DeKalb County Historic Preservation Commission

Staff Report

- I. 1146 Lullwater Road, David Price. Demolish a non-historic garage, construct a two-story addition at the rear of a non-historic addition and a porte-cochere on the rear right corner of a historic house, and install a pool in the rear of historic property. **1248227.**

Built in 1925 (18 002 06 071)

PROPOSED GARAGE FRONT ELEVATION
SCALE: 1/4" = 1'-0"

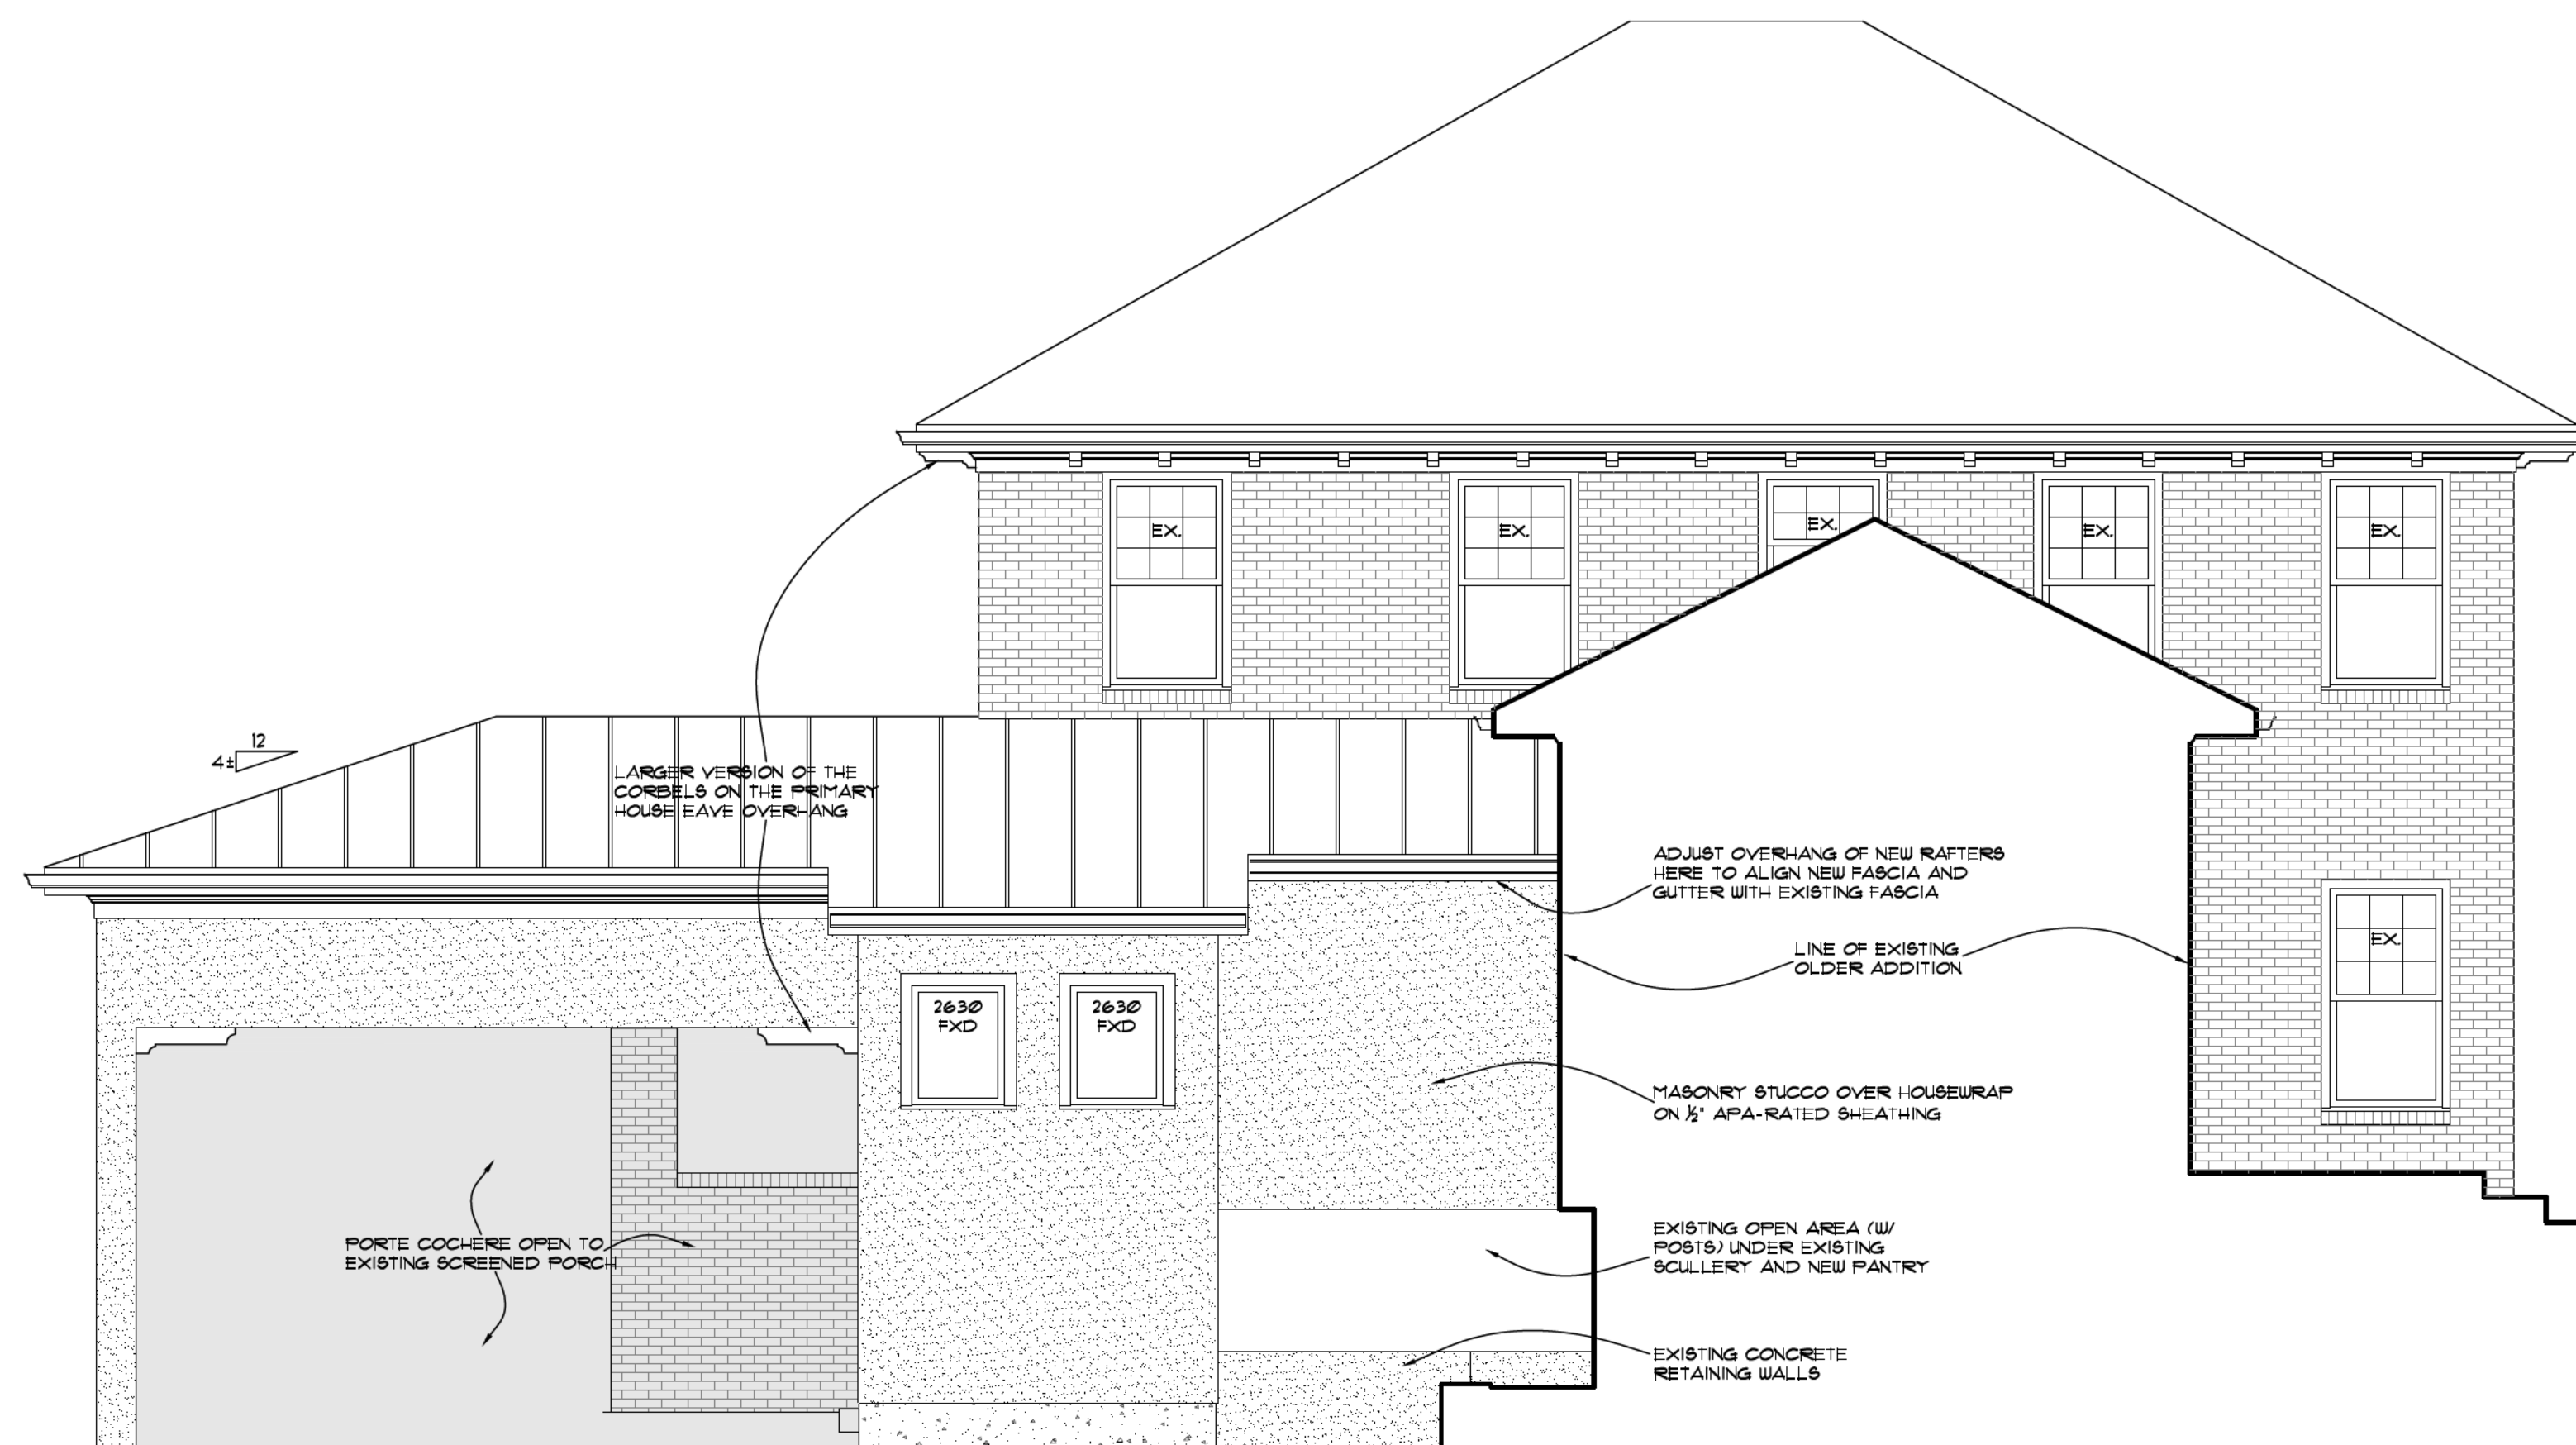
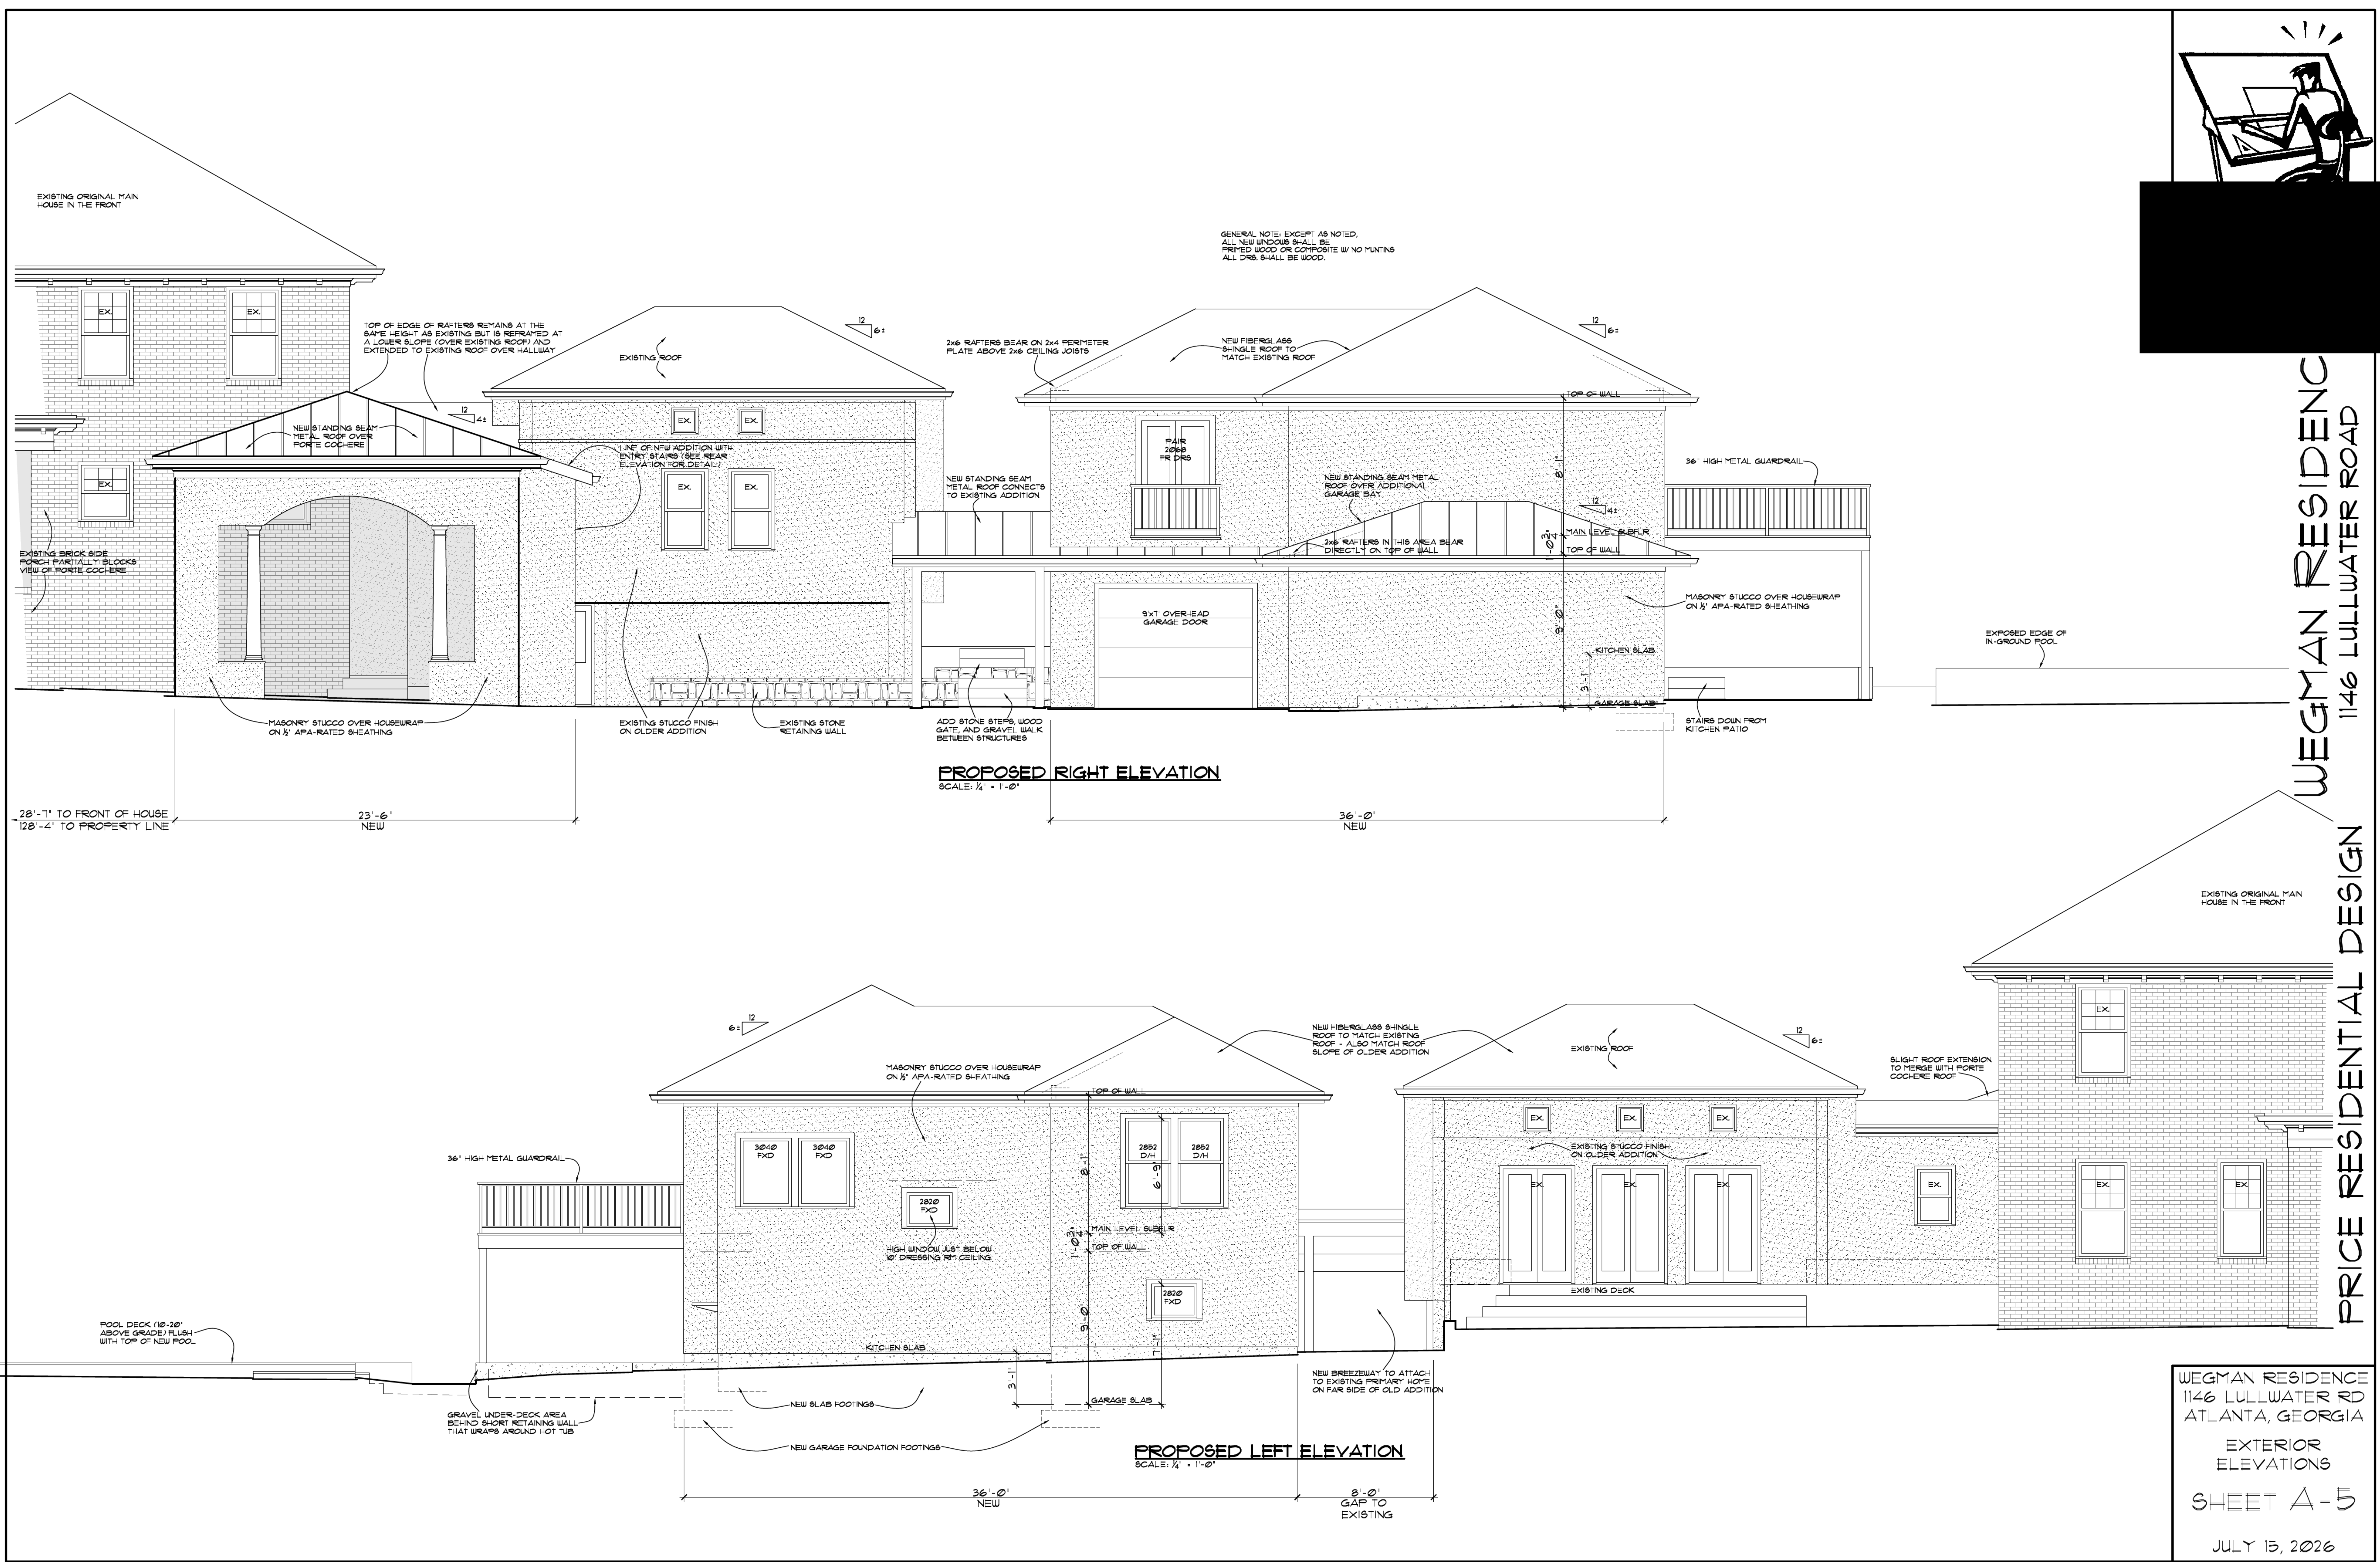
2. Construct a two-story addition to the rear of a nonhistoric addition. A two-story structure will be constructed in the backyard of the property, in the footprint of the existing nonhistoric garage and extending into the backyard, towards the Southern property line, to connect to the existing nonhistoric rear addition. The addition will measure roughly 25' from grade to roof ridge, with the ridge of the addition being roughly 12' below the roof ridge of the historic house. The nonhistoric structure will be constructed with a hipped, fiberglass shingle roof, masonry stucco siding, and primed wood or composite windows. The structure will also be constructed with hipped standing seam metal roofing covering the lower level and a covered breezeway connecting the structure to rear nonhistoric addition. Several single-car garage doors will be installed on the lower level of the structure as well.

What is the height of the proposed two-story addition from grade to roof ridge? The grade changes quite a bit from right to left but the garage slab is level with the lowest grade point, which is on the driveway. The driveway is at the exact same level as the existing driveway and garage. From that lowest point of the exterior grade to the highest point of the ridge, it is 24'-8". The garage slab is 7'-2" lower than the main house main floor level and the highest ridge is 11'-5" below the main house ridge.
